# **Intel® Mobile Pentium® III Processor Specification Update**

Release Date: February 2001

Order Number: 245306-016

Figure 7. BCLK Timing Waveform

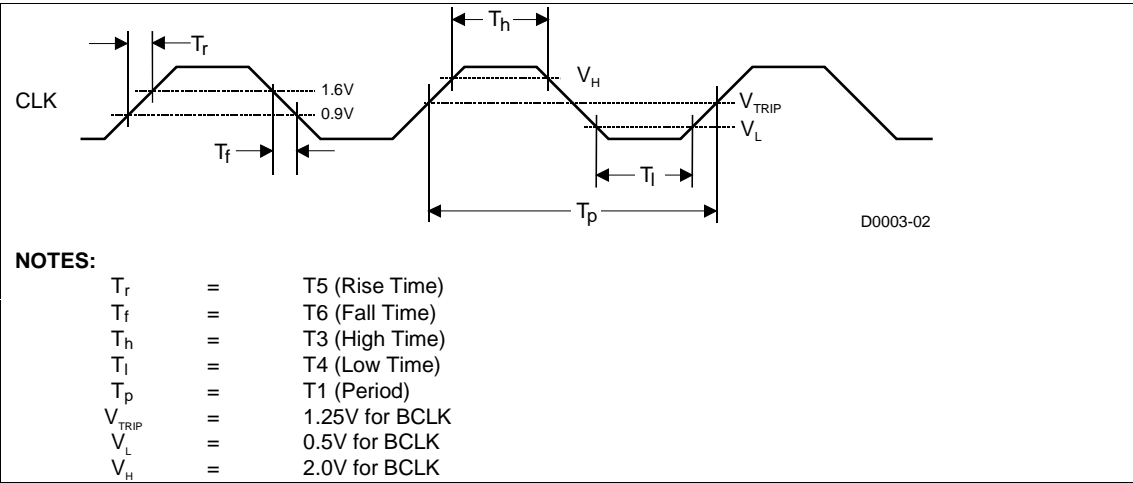
For B0 step processors, the  $V_{IH,BCLK}$  Min spec is changed to 2.0V (from 1.7V for A2 step) and  $V_{IL,BCLK}$  Max spec is changed to 0.5V (from 0.7V for A2 step). Due to this, new values are specified for BCLK high and low times for B0 step processors. These modifications affect corresponding specs in Table 13, Table 14, Table 24, and Figure 7 in *Mobile Pentium® III Processor in BGA2 and Micro-PGA2 Packages datasheet* (Order Number 245302-002).

The following tables and figures highlight the above mentioned BSEL[1:0] and BCLK specs modifications made for B0 step processors:

Symbol	Parameter	Min	Typ	Max	Unit	Figure	Notes
	System Bus Frequency		100		MHz		
T1	BCLK Period		10		ns	Figure 7	Note 2
T2	BCLK Period Stability			$\pm 250$	ps		Notes 3, 4
T3	BCLK High Time	2.70			ns	Figure 7	at >2.0V
T4	BCLK Low Time	2.45			ns	Figure 7	at <0.5V
T5	BCLK Rise Time	0.175		0.875	ns	Figure 7	(0.9V – 1.6V)
T6	BCLK Fall Time	0.175		0.875	ns	Figure 7	(1.6V – 0.9V)
